Response to 802.3dj D2.3 Comment #44 Test Vectors for Clause 186 FEC (800GBASE-ER1, ER1-20)

802.3dj Interim Meeting, Austin, January 2026

802.3dj D2.3 Comment #44

1 x 800GE Test Vectors

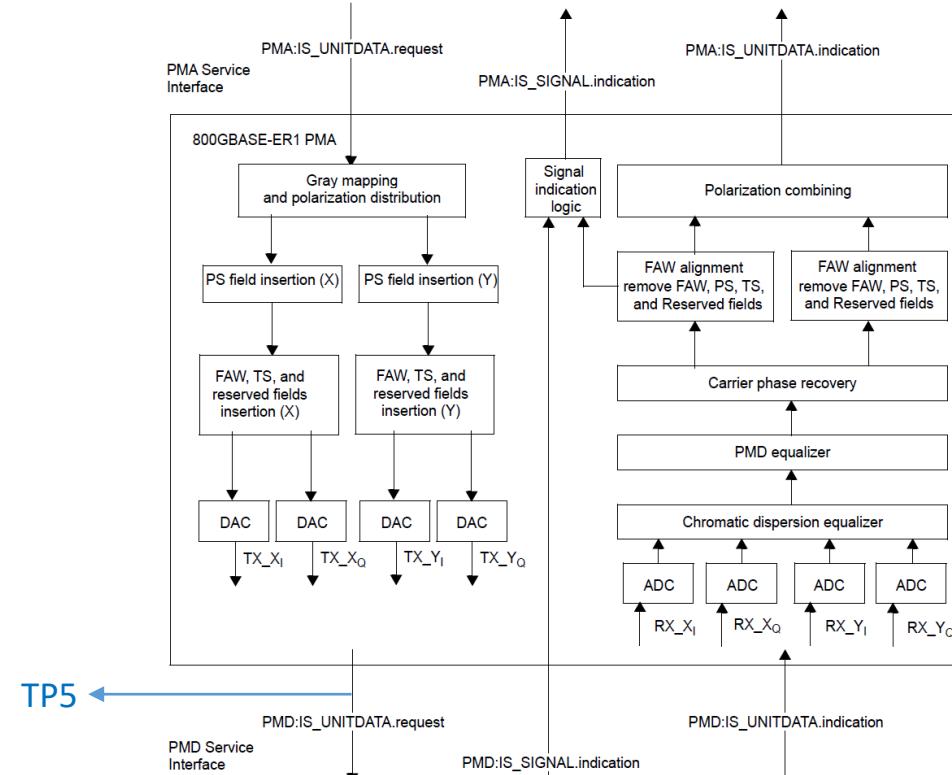
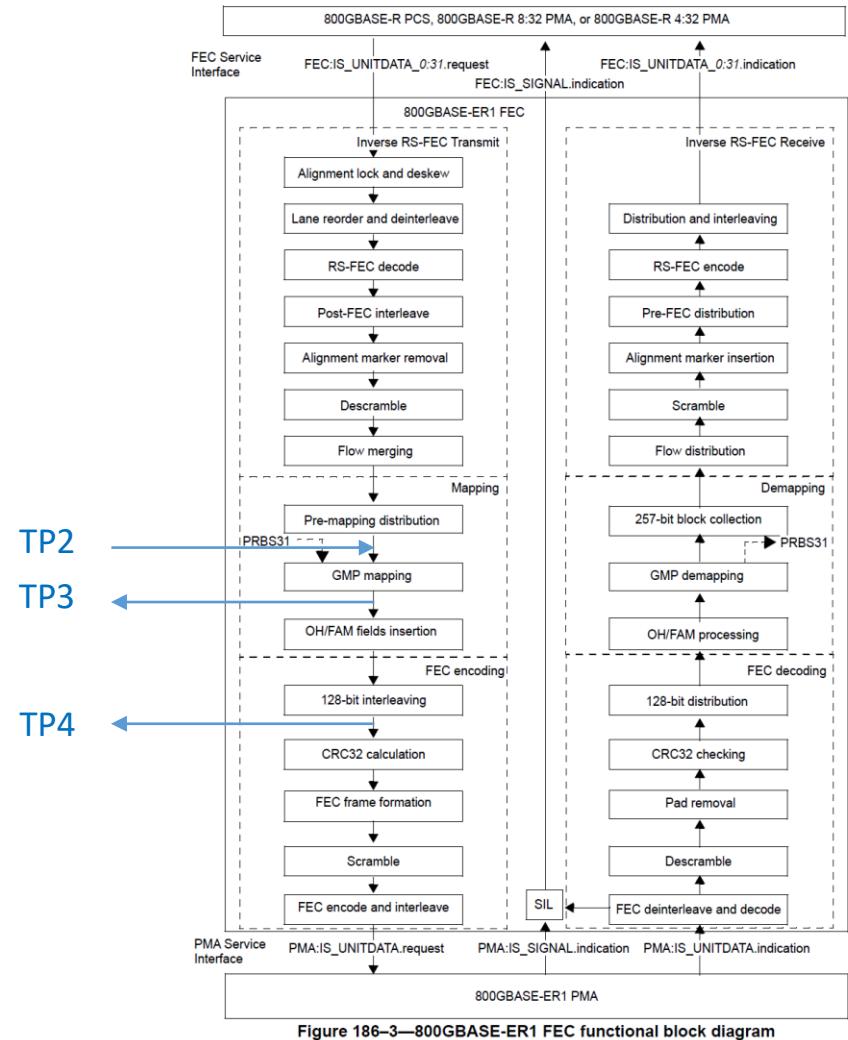
Draft 2.2 comment #152 requested that test vectors be incorporated into the draft. The response pointed out that relevant test vectors are provided publicly by OIF but need some exceptions. During comment resolution, one participant offered to provide appropriate text vectors.

Provide text vectors for Clause 186 FEC or reference the OIF test vectors noting exceptions.

- Payload bits are a specific test pattern of Ethernet packets encoded and transcoded per IEEE 802.3 Clauses 172.2.4.1 to 172.2.4.4 for 800GBASE-R.
- Idles have been added between packets to generate average IPG=12 and to diversify the cases for the 64B/66B->256B/257B transcoder.
- Output symbols for this test are included.

Note: using a transcoded Idle test pattern (because unscrambled in the case of 800GE client GMP mapping) would not provide sufficient randomization of the data and test coverage: i.e. the GMP payload would be mostly zeros in this case).

- These test vectors do not support the optional alignment marker location feature – Users of these vectors should assume that FEC status variable: FEC_alignment_marker_location_ability, and/or FEC control variable: FEC_alignment_marker_location_enable are configured to zero. Under these conditions, the value of the AML overhead == all-zeros.
- Test Vector files:
 - Input reference point: TP2
 - Monitoring point: TP3-TP5

- Adopt the test vectors contained in Sluyski_3dj_02_2601 in response to 802.3dj D2.3 Comment #44, as the test vectors for Clause 186A.
